STATE OF HAWAII
DEPARTMENT OF LAND AND NATURAL RESOURCES
COMMISSION ON WATER RESOURCE MANAGEMENT
P.O. BOX 621
HONOLULU, HAWAII 96809

STAFF SUBMITTAL

August 29, 2019
Wailuku, Hawaii

Approval of a Stream Diversion Works Permit Application (SDWP.4950.6)
by East Maui Irrigation Company to Remove and Abandon 11 Diversions (Category 3)
on the Honopou, Hanehoi (Puolua), and Pi'ina'au (Palauhulu) Streams,
East Maui Irrigation System, East Maui, Hawai'i; TMK: Various

Figure 4. Stagnant water standing in depressions created by the walls and the gate structure.

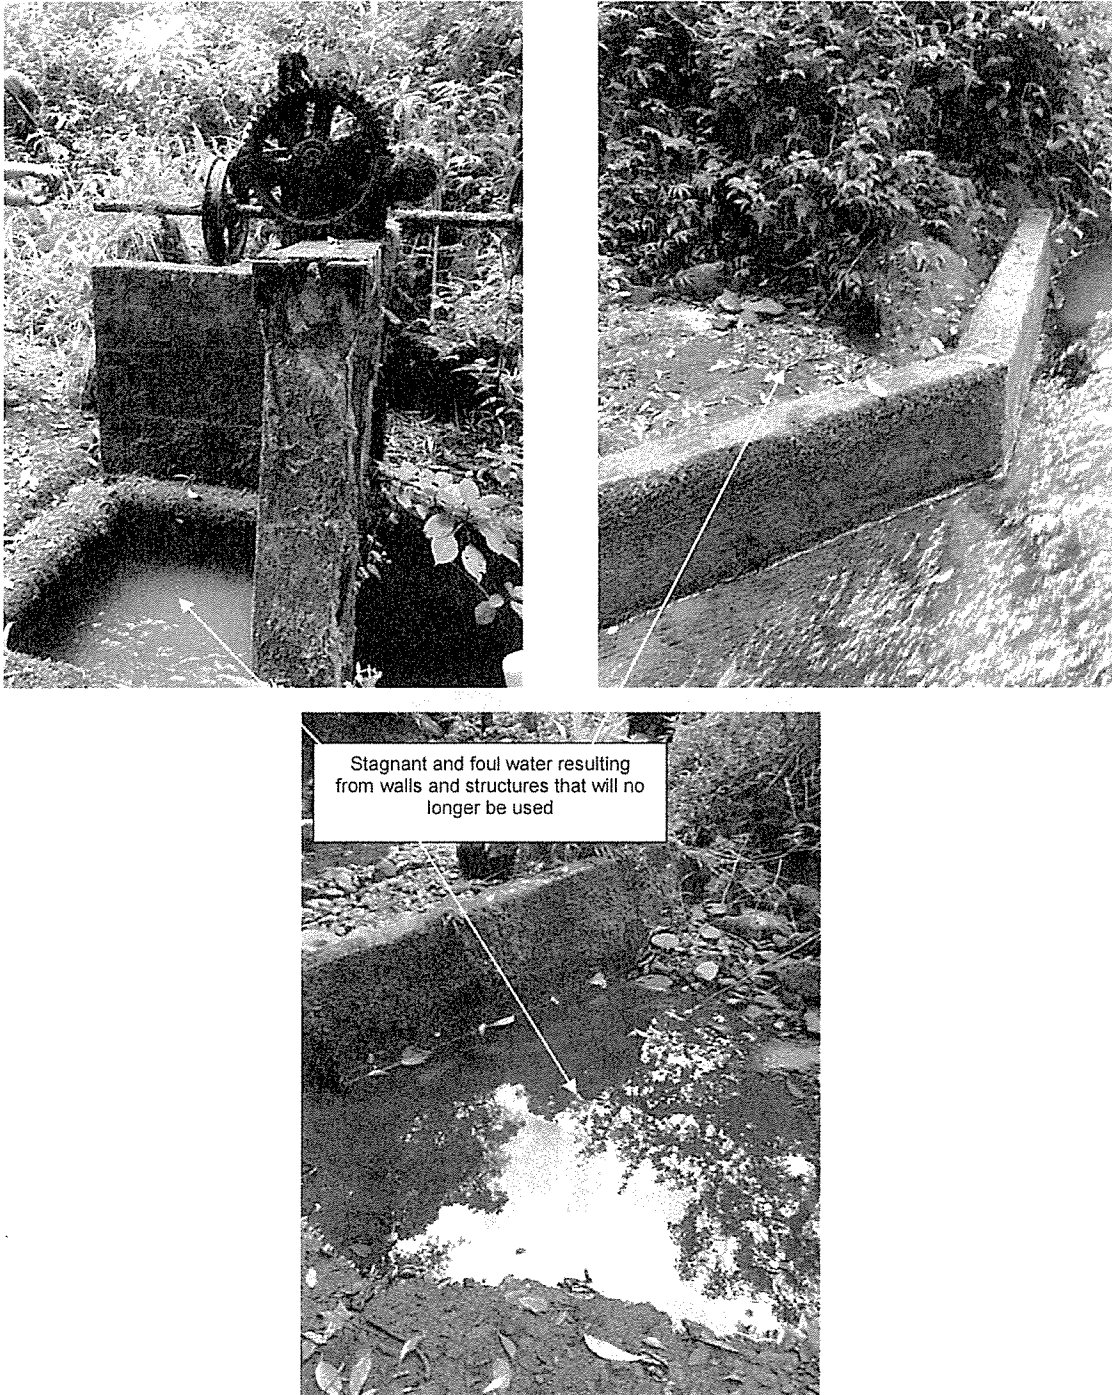
(a) In addition to the measures identified in the application to seal the grate, remove the walls to restore the natural stream flow and eliminate mosquito breeding sites.

(b) Prevent stagnant water and mosquito breeding sites sealing the sluice basin or other measures to avoid water standing in the structure.

Figure 5. Wall across stream bed creates a dam that that alters flow and creates standing water.

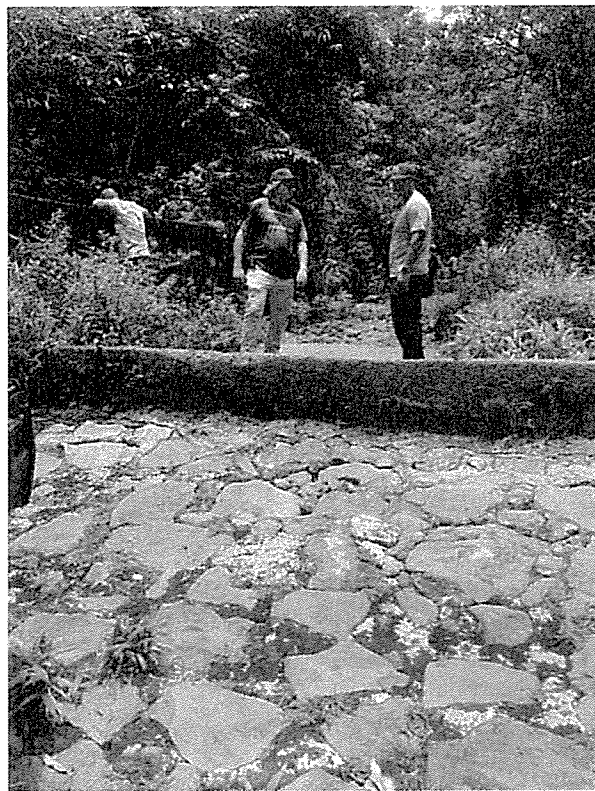
- ii) Hanehoi Huelo intake at New Hamakua ditch (NH-17)
 - (1) Comments
 - (a) The wall across the stream bed creates a dam that obstructs the natural course of the stream.
 - (2) Recommendations
 - (a) In addition to the measures identified in the application to seal the grate, please remove the wall across the stream bed to restore the natural stream flow.

Figure 8. East Wailuanui at Koolau ditch (K-18). Stagnant water outside the west wall (top left), wall crossing stream (top right), stagnant water on the east side of the stream.

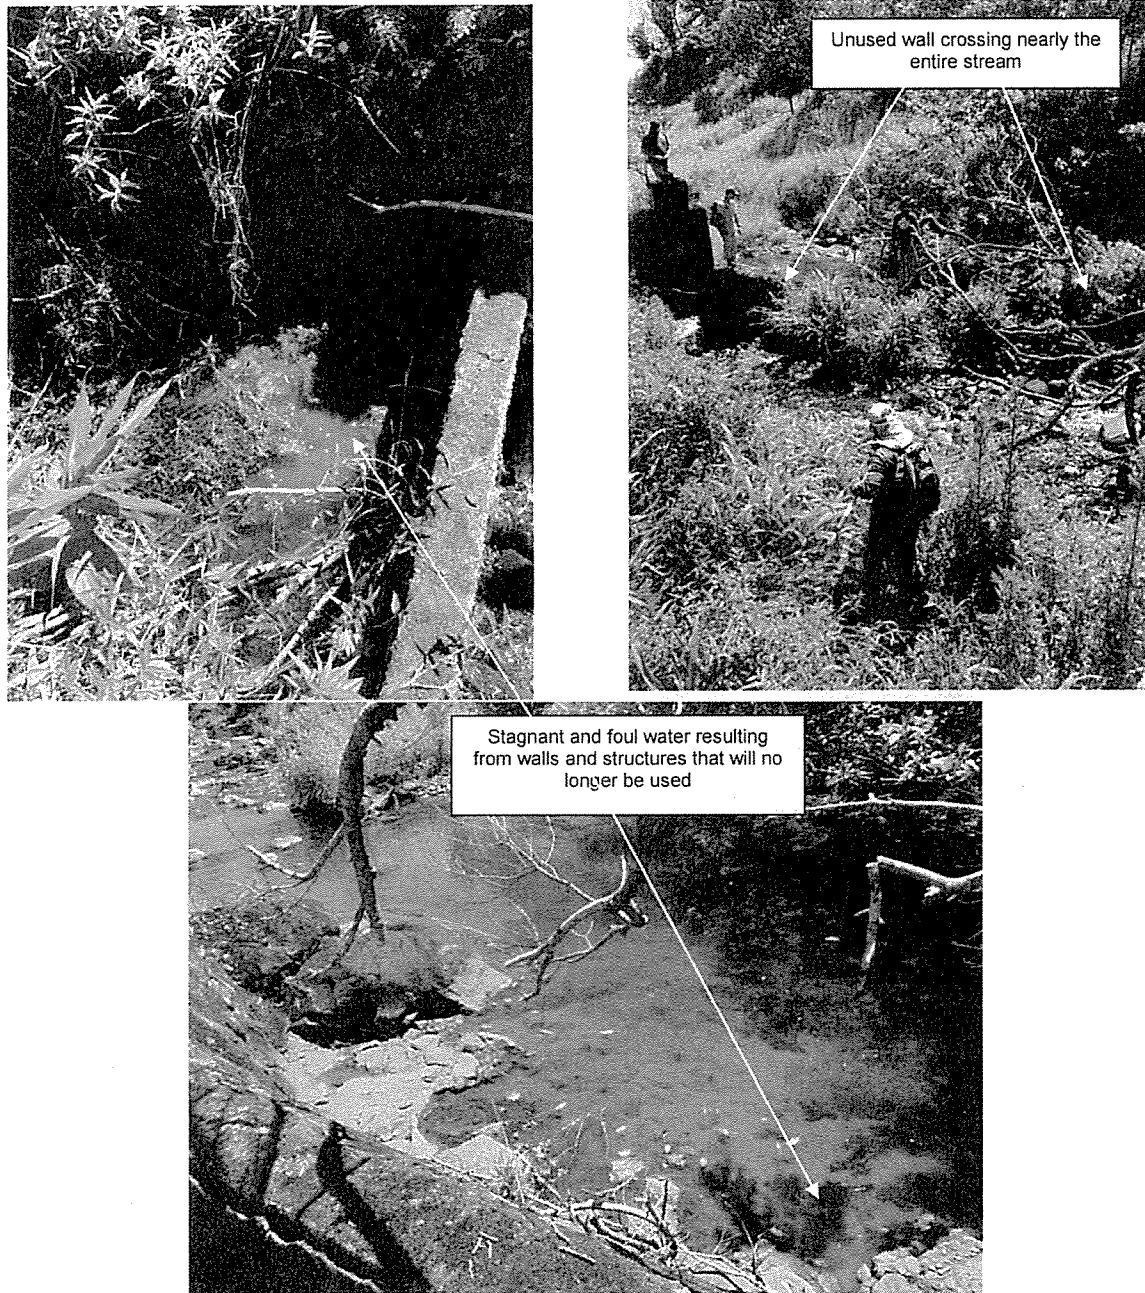
(b) The walls trap standing water on both sides of the stream, as well as in the intake, which we found to be very stagnant, creating breeding sites for mosquitoes. The application proposes to permanently remove the sluice gate to restore stream flow and to fill the intake with concrete.

(a) Remove the walls on the east and west side of the stream in their entirety. Those walls will no longer be used for diversion purposes and their presence creates large areas of stagnate water that creates breeding sites for mosquitoes.

(c) Remove the pillar and structures at the intake since they will no longer be used for water diversion purposes.

Figure 9. Channel to enable stream to cross ditch (left). Control house at K-19 (right).

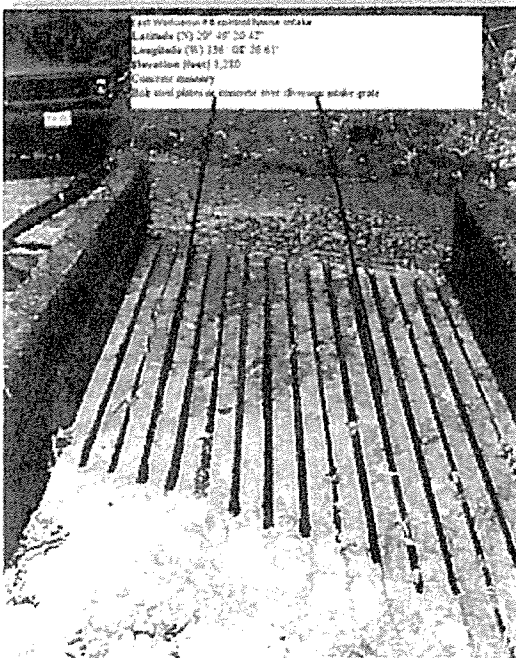
- (a) The channel that is created by the walls is relatively narrow and low. It is unknown whether it may should be monitored regularly to ensure that it does not become obstructed by debris.
- (b) The control house and related structures should be removed if they are no longer in use.

Intake K-21 W. Wailuanui stream Ko'olau ditch
on State land
Status: to be fully and permanently restored.

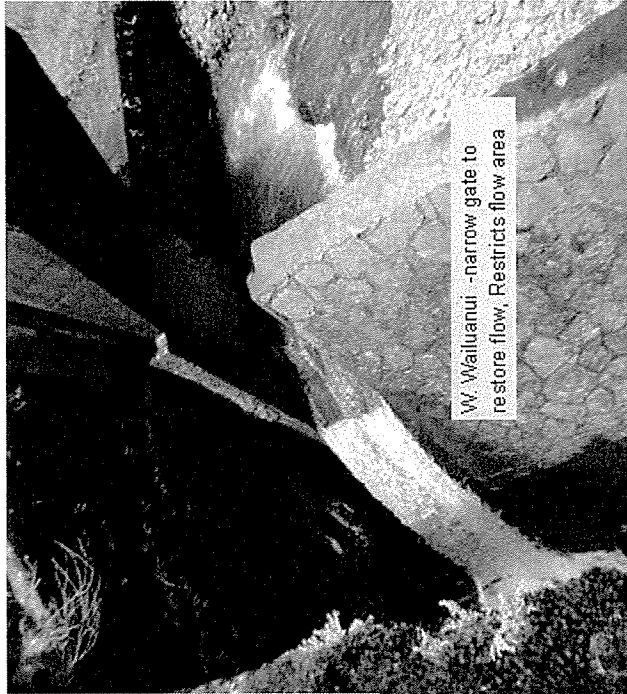
Permit Action: NONE. Gate removed.
Streamlife left with very limited migration path due to two large
dam structures
Recommendation: Remove unneeded dam structures to create
more natural stream bed

W. Wailuanui -narrow gate to
restore flow, Restricts flow area

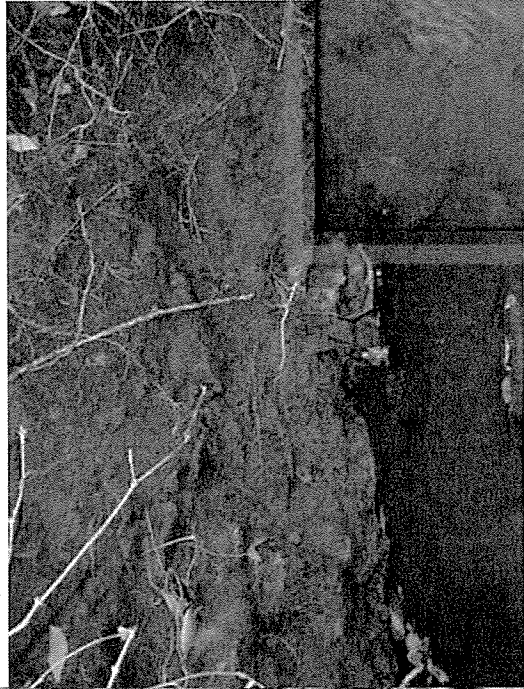
**Permit Action: CAT.1. Gate removed/grate sealed
Unneeded debris basin facilitates accumulation of stagnant
water and mosquito breeding; Flow concentrated in one spot
erodes soil banks and silts up water.**

**Recommendation: remove unneeded dam/ catch basin
structures create more natural flows**

Intake K-25 Kikokiko waterfall leads by pipe to Ko'olau ditch

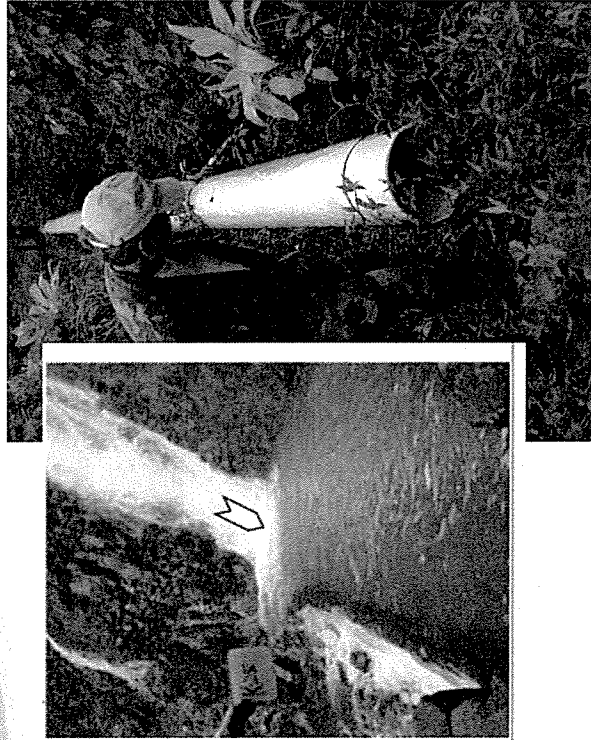
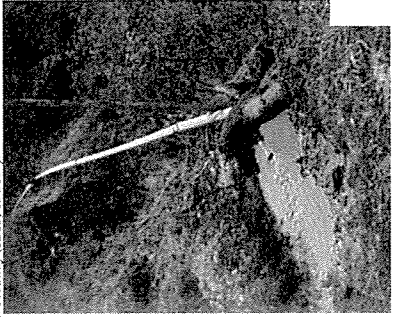
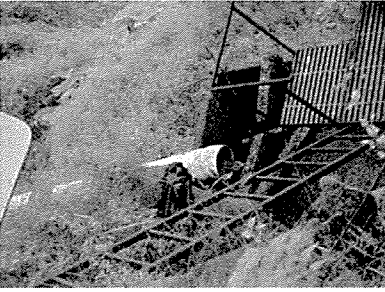
Main Kikokiko 6-in intake pipe - severed and no longer operational

Permit Action: Cat 4. Pipe severed but not removed at its source

Recommended Action: remove unsightly pipes on public land
